Company: Eugene School District 4J
Project: **Twin Oaks ES South Parking Lot Upgrade**
C.I.P. 420.343.009

Subject: Addendum #1

From: Roberts Consulting & Engineering
3220 Tilden Street, Suite A
Eugene, OR 97404

C3.0r

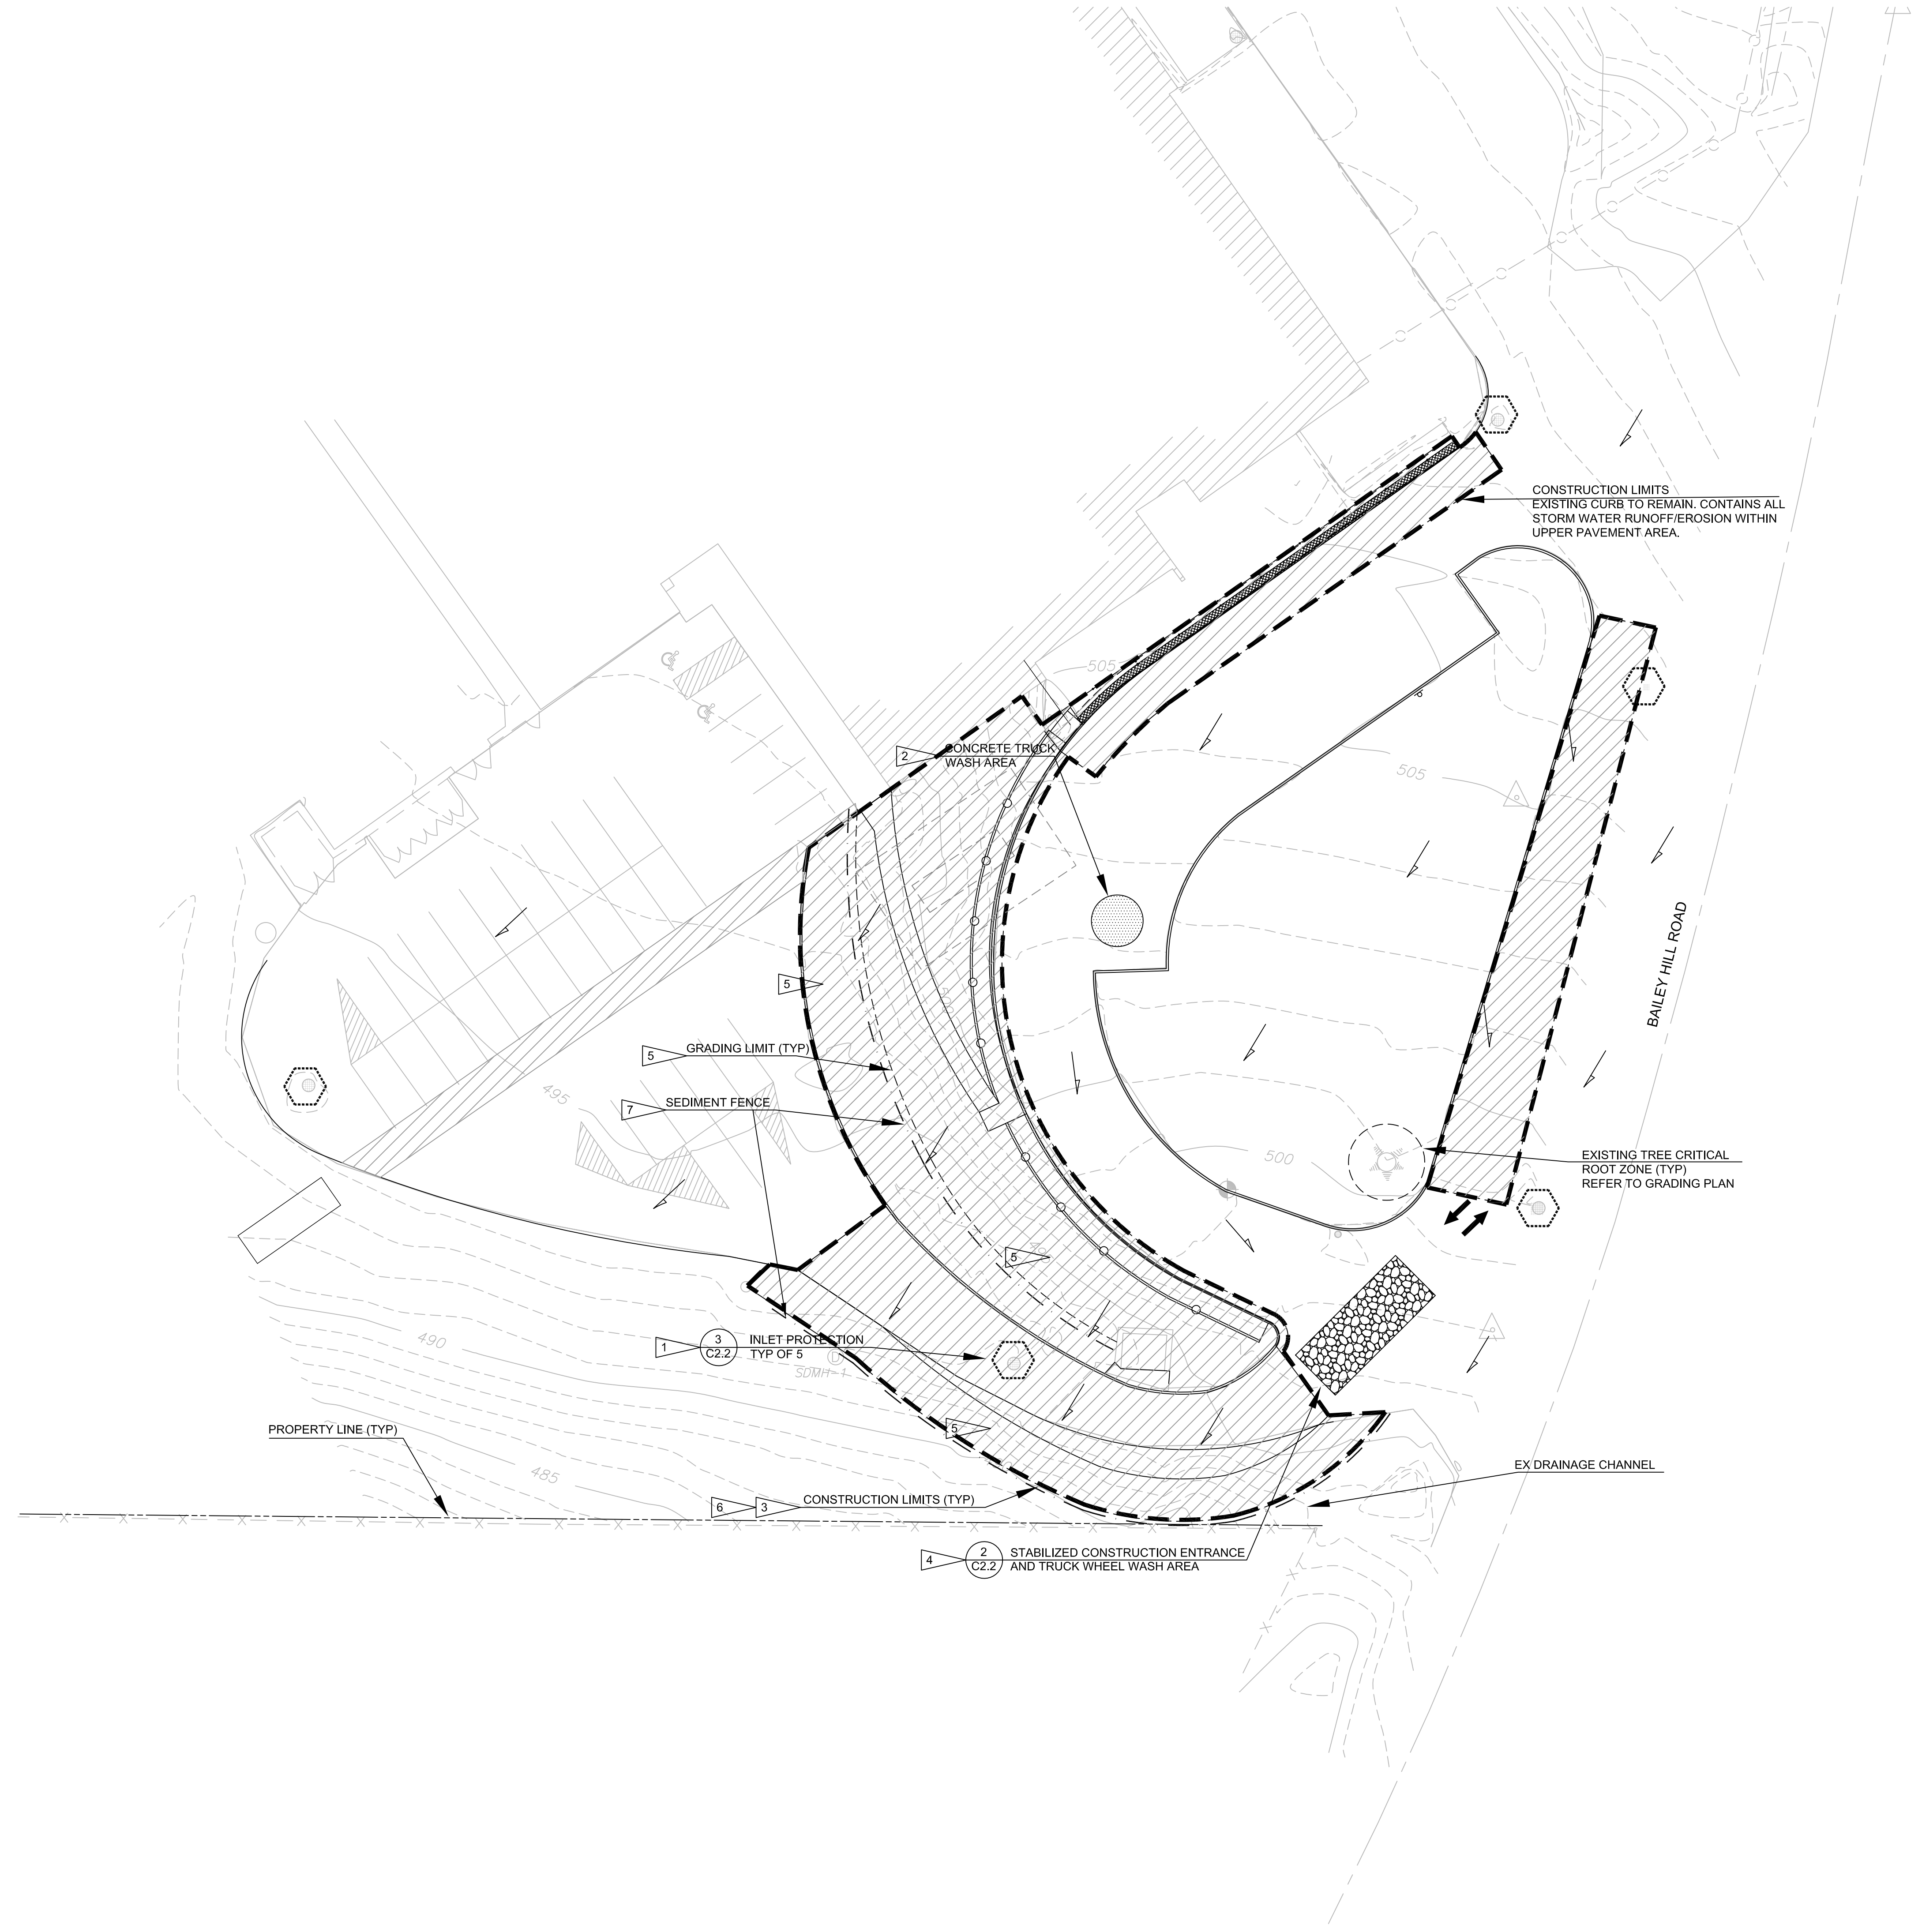
1. Replace Drawings C2.0, C3.0, C5.0 and C7.0 with C2.0r, C3.0r, C5.0r, C7.0r.
2. Add to Construction note 2: "EXTEND PIPE, AS RQUIRED, TO DAY LIGHT THROUGH TRANSITION GRADING AREA".

C7.0r

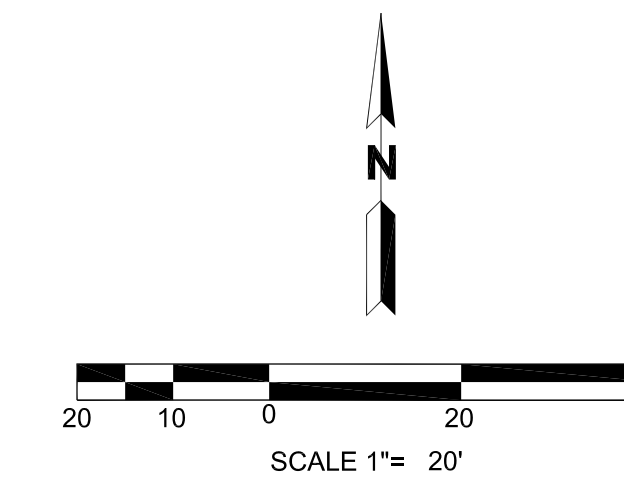
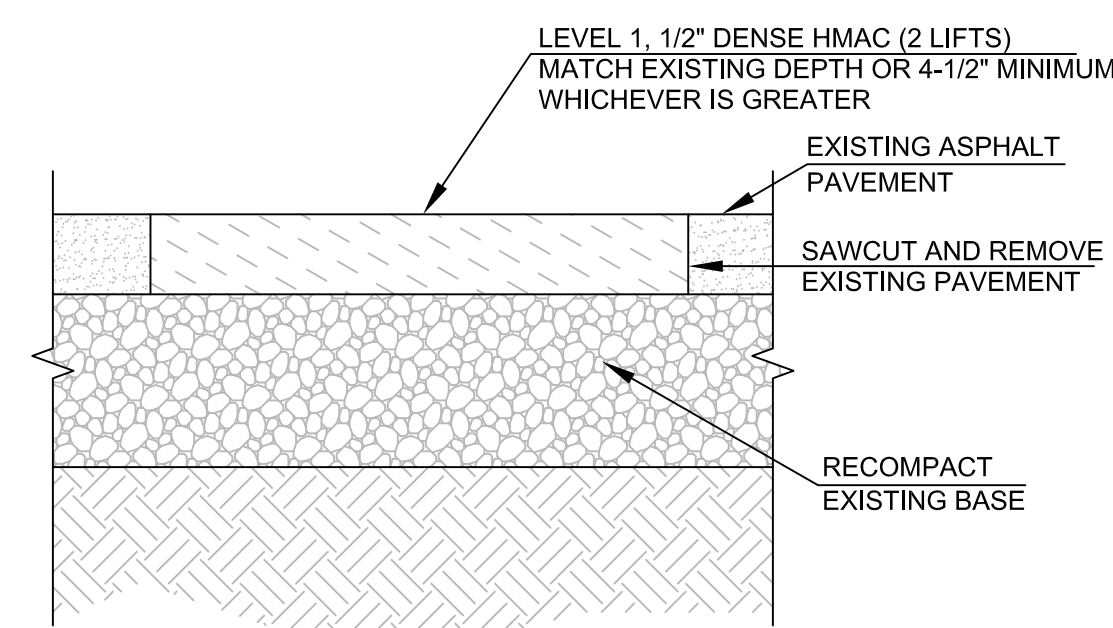
1. "Reconstruction" of south access drive lane requires change in grading and replacement of entire pavement section (Asphalt and gravel base). All other pavement "replacement" areas require removal of existing asphalt, compaction of existing base rock and then placement of new asphalt.
2. Referenced Document 00 41 13 BID FORM:
Unit price Item 2. Asphalt Replacement is for detail 2/C7.0 and does not include south access drive "reconstruction".
